FINAL REMEDIAL DESIGN REPORT

**SEDIMENT REMOVAL AT
CHERRY FARM SITE (NYSDEC SITE NO. 9-15-063)
RIVER ROAD SITE (NYSDEC SITE NO. 9-15-031)
Tonawanda New York**

**CHERRY FARM / RIVER ROAD SITE
PRP GROUP**

PARSONS ENGINEERING SCIENCE, INC.
180 Lawrence Bell Drive, Suite 100
Williamsville, New York 14221
(716) 633-7074 FAX (716) 633-7195
Buffalo, New York

CHERRY FARM/ RIVER ROAD
SEDIMENT REMOVAL
FINAL GRADING PLAN

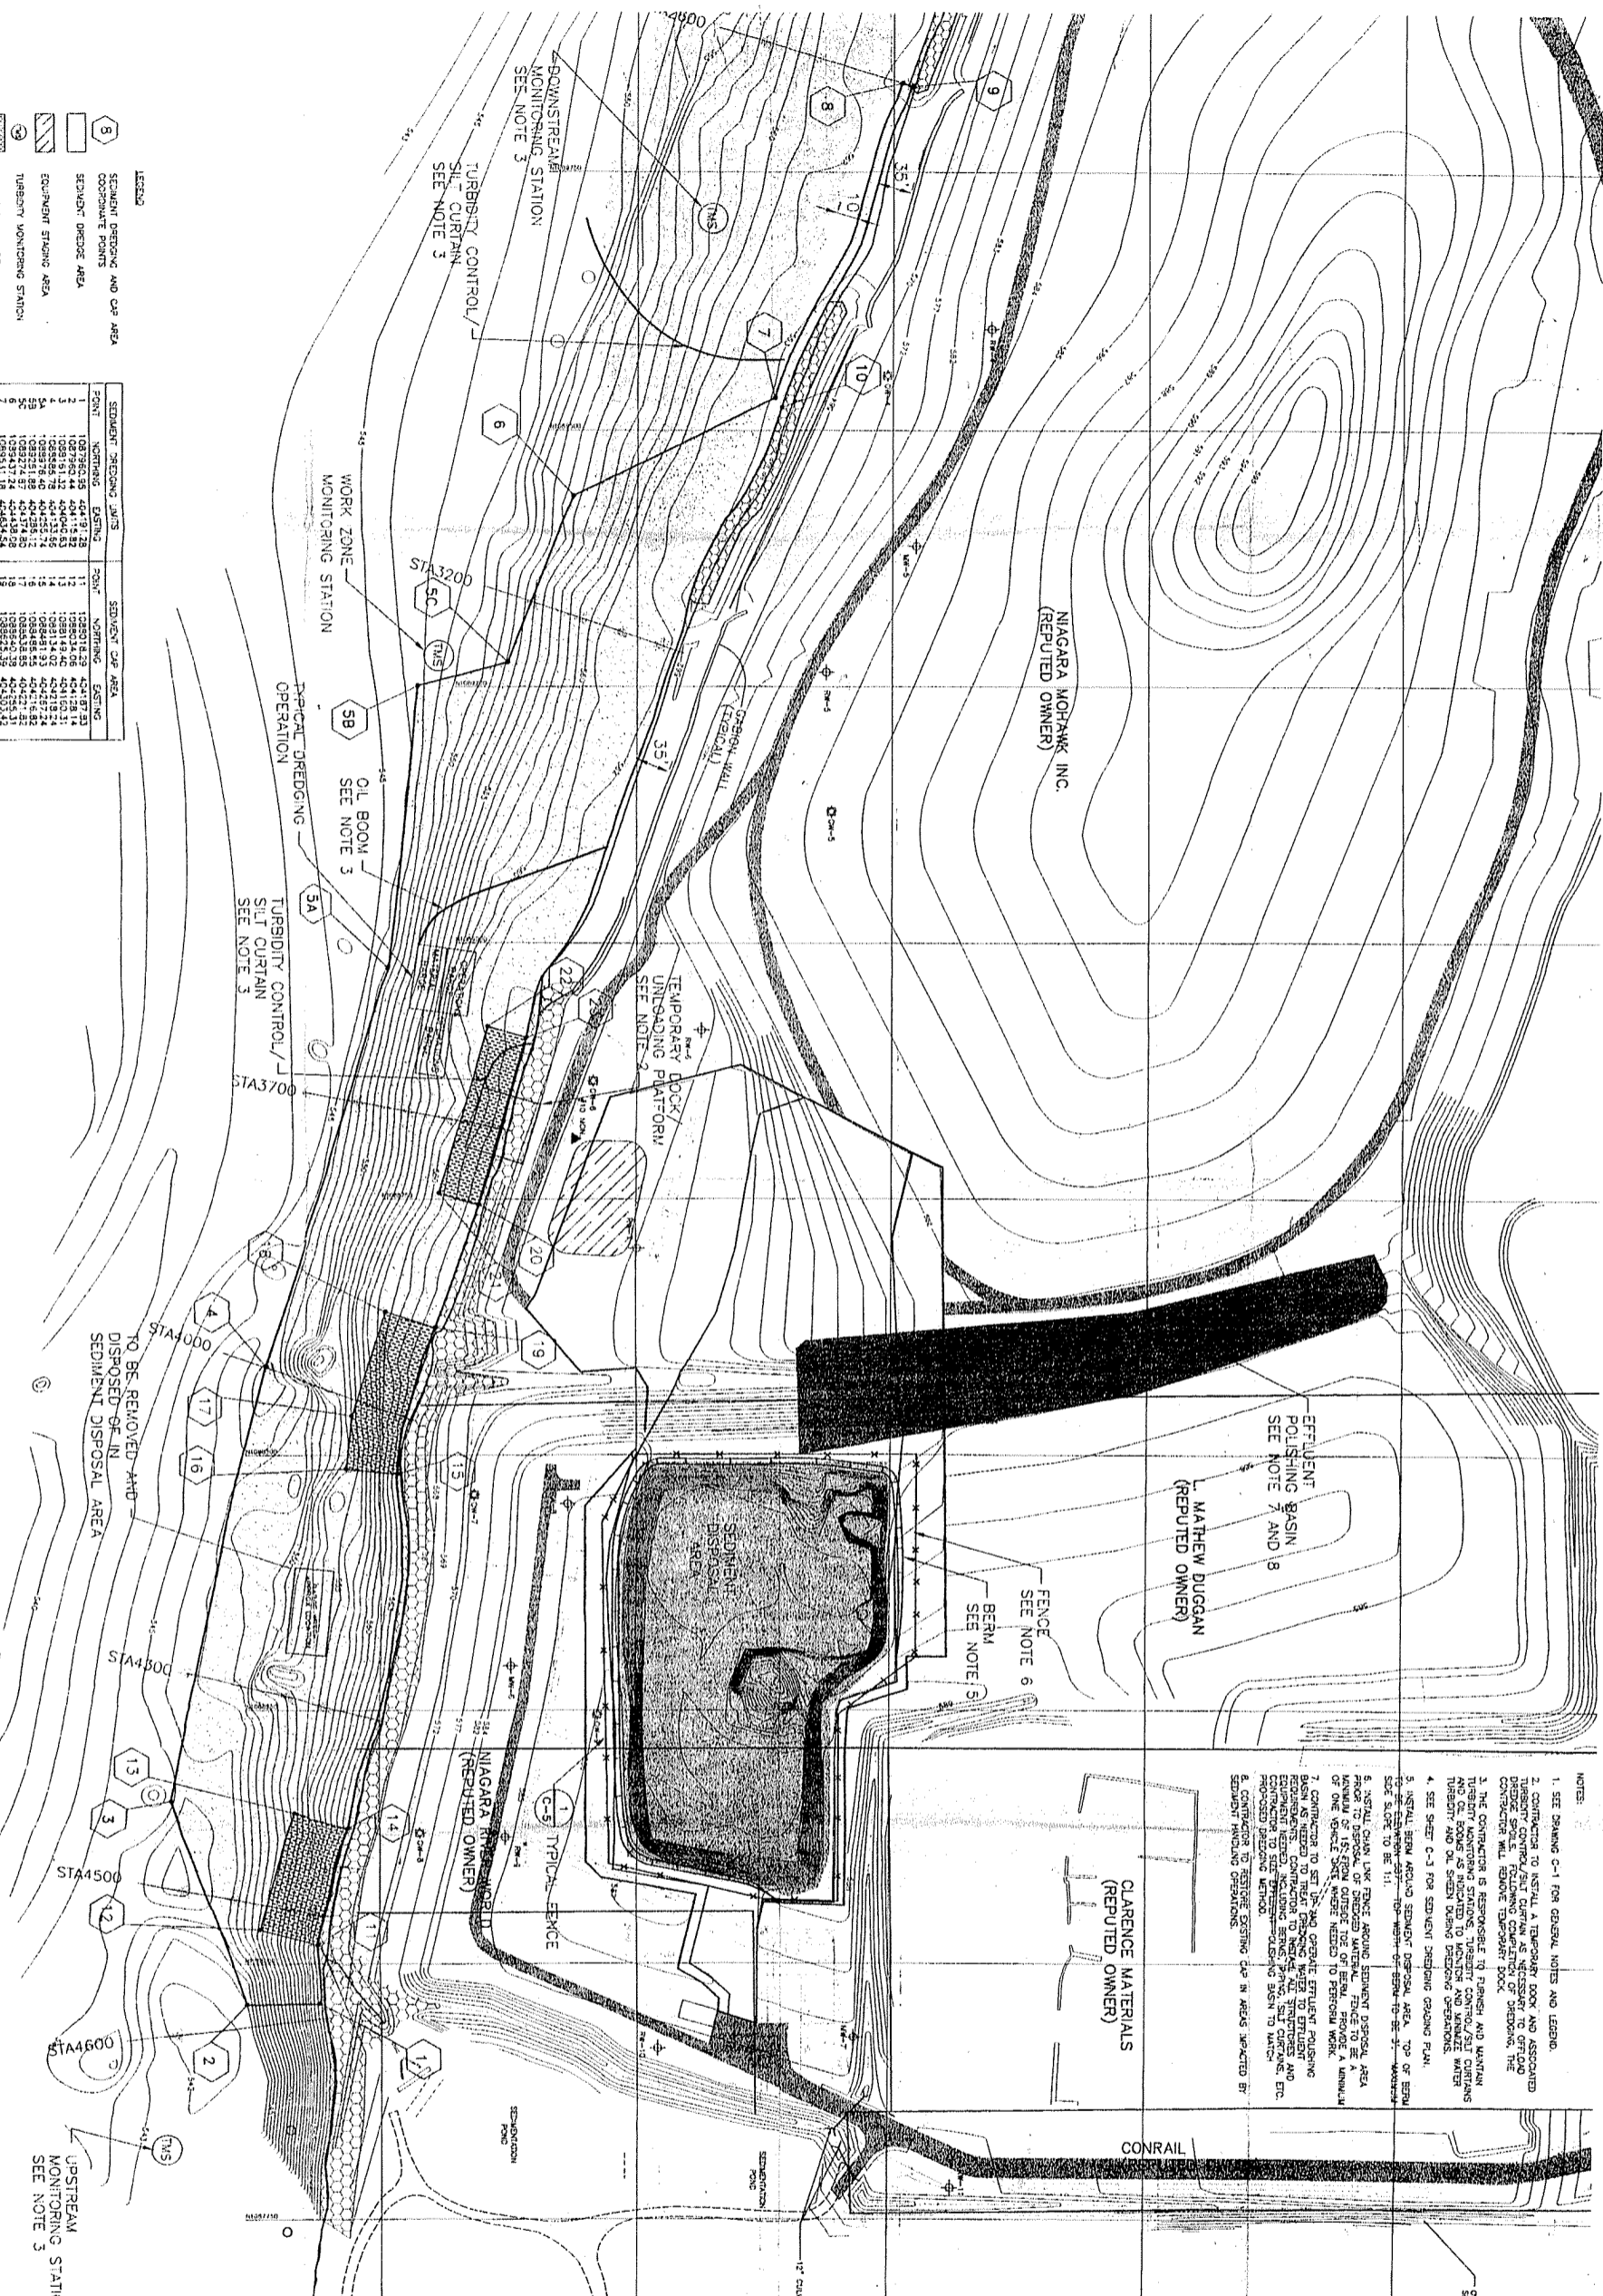
3. Question: Drawing C-1 indicates that the area north of the SDA is not to be capped. Drawing C-3 indicates that the same area is to be capped. Which is correct?

4. Question: Drawing C-1 and C-3 conflict regarding the need for topsoil in the cap. Which drawing governs?

Answer: Drawing C-3 shows the correct areas to be capped. Drawing C-1 represents existing conditions, and should not be used to determine work to be performed.

Answer: Topsoil is needed wherever capping is to be performed. Again, Drawing C-3 should be used to determine work to be done.
